## OPTIONAL SERVICE BULLETIN OSB D4-098/1

supersedes RSB D4-098

Installation of new ECU 05-7611-001904

# WORK INSTRUCTION WI-RSB D4-098

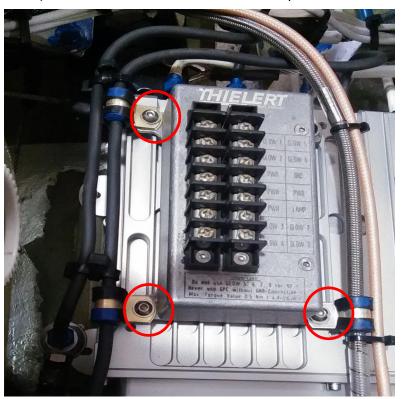
1	Remove pilot seat i.a.w. AMM Section 25-10.	
	Disconnect the passenger floor heating hose from the foot well lining (refer to grey line in picture below).	
2		
3	Remove the glow control box from the ECU.	
4	Disconnect both MAP lines from the ECU.	
5	Remove the MAP tubes from the MAP hose.	
6	Replace the ECU with the new ECU 05-7611-001904.	
7	If RSB D4-083/1 or MSB D4-104 is not installed: Install water separators i.a.w. MSB D4-104.  Note Compliance with RSB D4-083 does not constitute compliance with RSB D4-	
	083/1 or MSB D4-104.	
8	Connect the water separator assemblies to the MAP hoses with an 13.8 Oetiker I-ear clamp.	
9	Install the glow control box on the new ECU.
